October 9, 1978

Subject: Proposed Changes to Radiological Technical Specifications  
Cooper Nuclear Station  
NRC Docket No. 50-298, DPR-46

Figure 6. 1. 2  
Cooper Nuclear Station  
Organization Chart

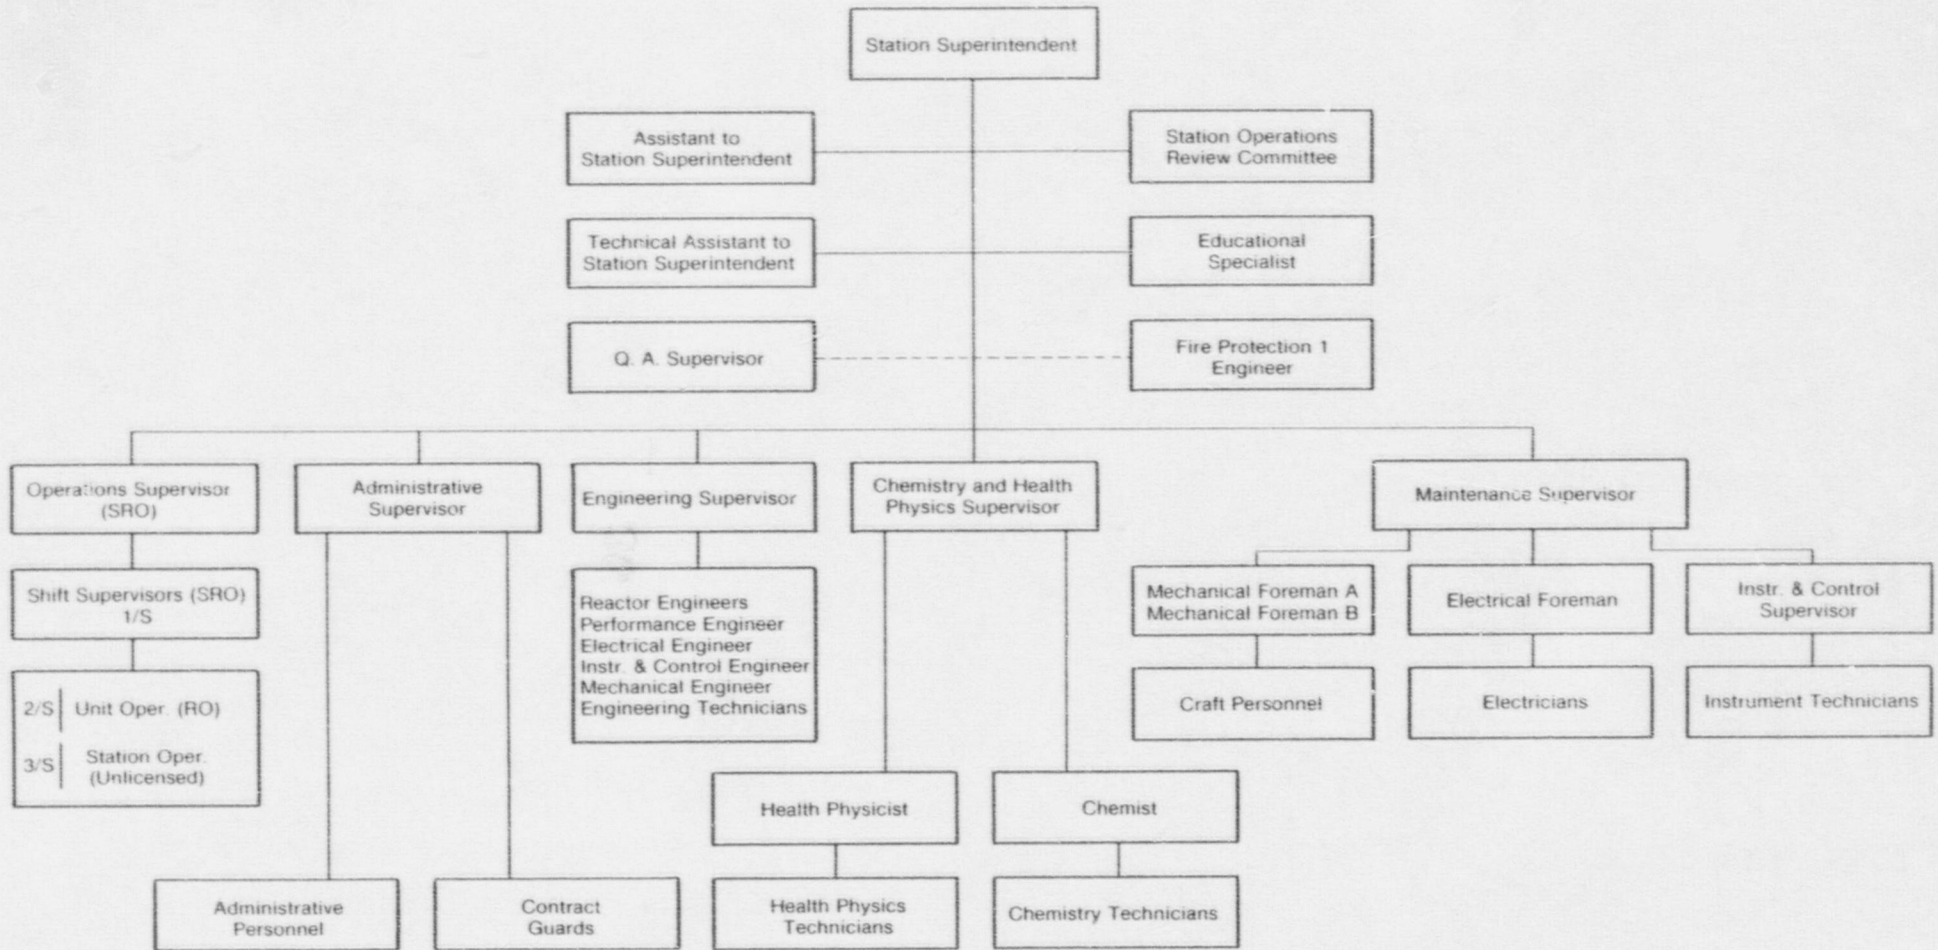
3. Figure 6.1.2. Cooper Nuclear Station Organization Chart

A letter dated July 26, 1978 from G. L. Madsen (NRC) to NPPD reported the results of a routine inspection conducted at Cooper Nuclear Station July 11-14, 1978. Section 5 of this report noted that while Technical Specification Figure 6.1.2 indicates a Reliability Engineer assigned to the Station Superintendent's staff, the actual site organization included a Technical Assistant to the Station Superintendent. Figure 6.1.2 is being revised to reflect the present station organization. One item revised on Figure 6.1.2 is the Station Operators (unlicensed) from two per shift to three per shift. Technical Specification 6.1.3.F is also being revised to agree with the figure in this regard. Three unlicensed operators are presently required for a fire brigade in Technical Specification 6.1.3.G.
